802.3da D1p3 Comment Support

6/25/2024

Booleans in State Diagrams

Settling Time for Mark and Low Event Measurements

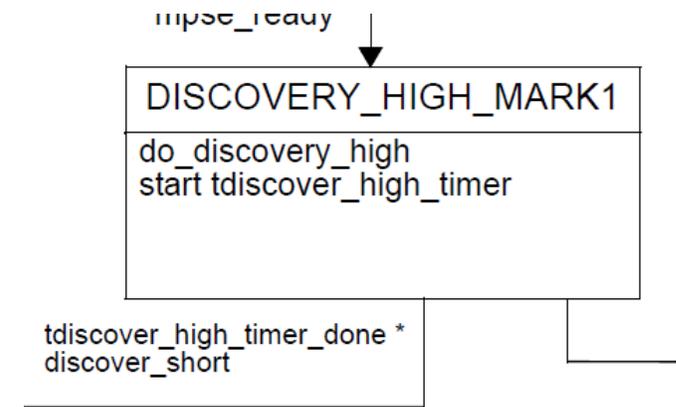
- MPSE Discovery events need time to settle before measurement
- State diagram rules say actions occur “on entry” instantaneously
 - Therefore, discovery states need to be split so that voltage can be “presented”, timed to settle, and then measured.
- Text at Page 106 line 28 already says this, but it is contrary to the state diagram, so the state diagram prevails

Representing Settling Time

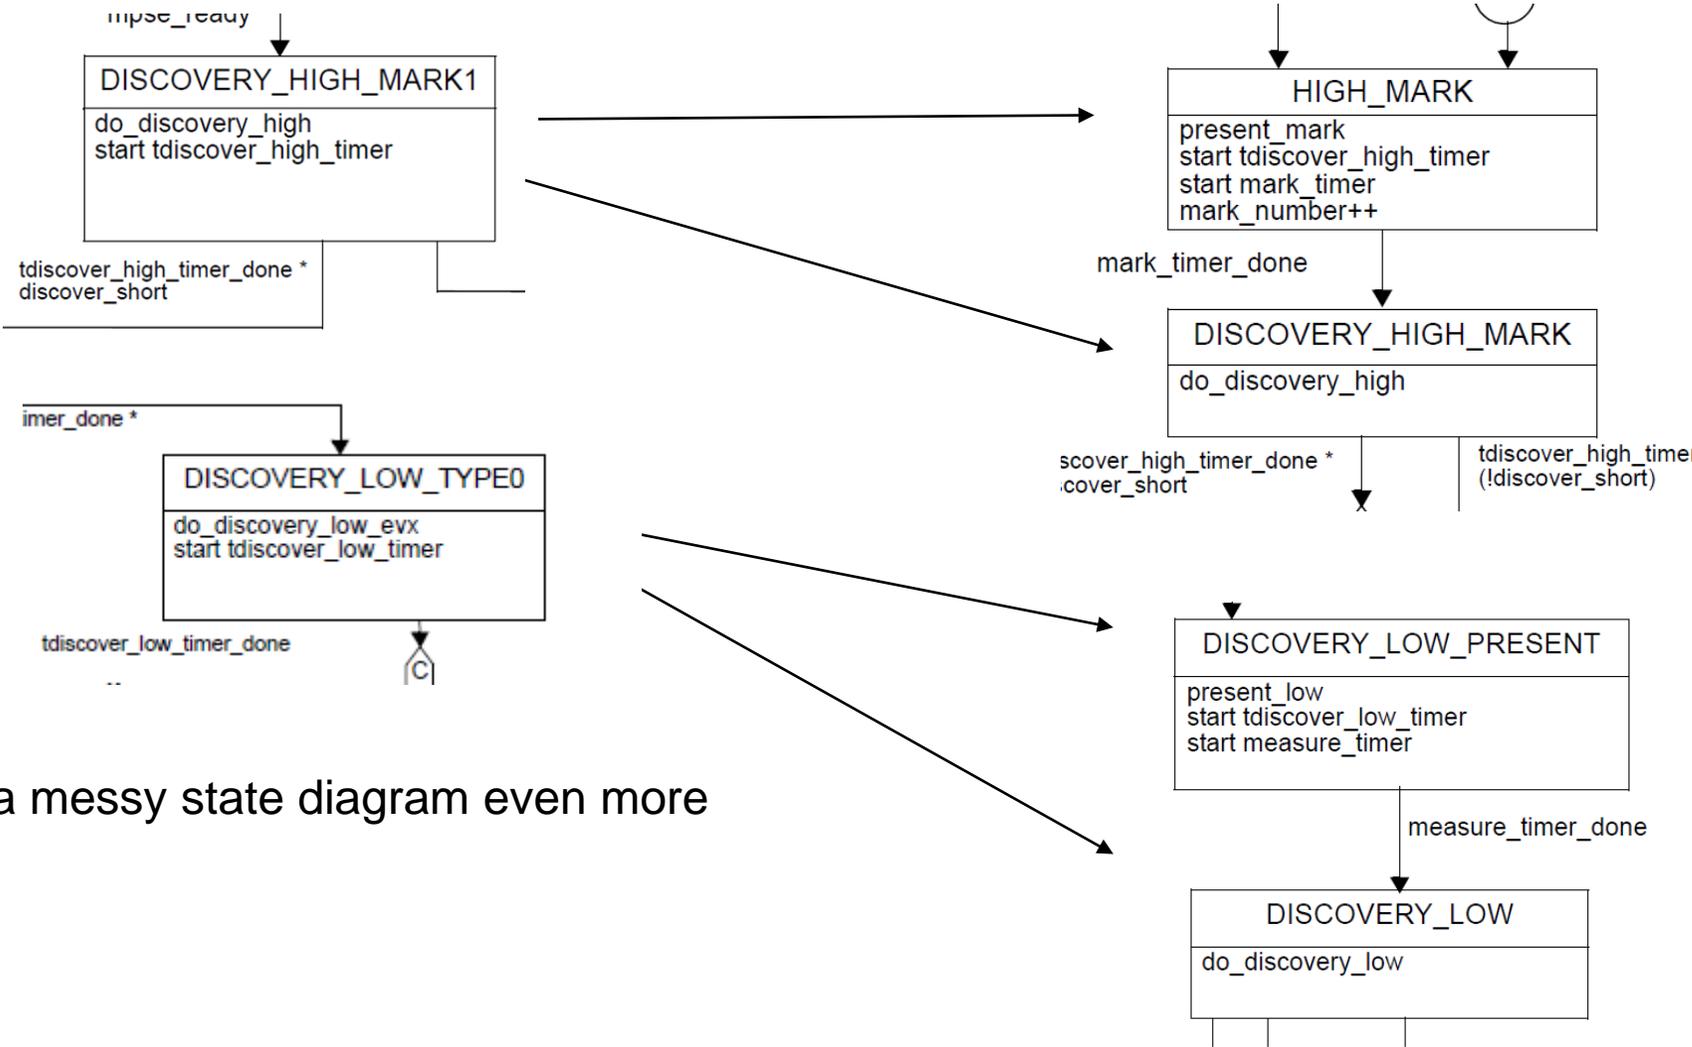
BUT – this makes a messy state diagram even more difficult to follow....
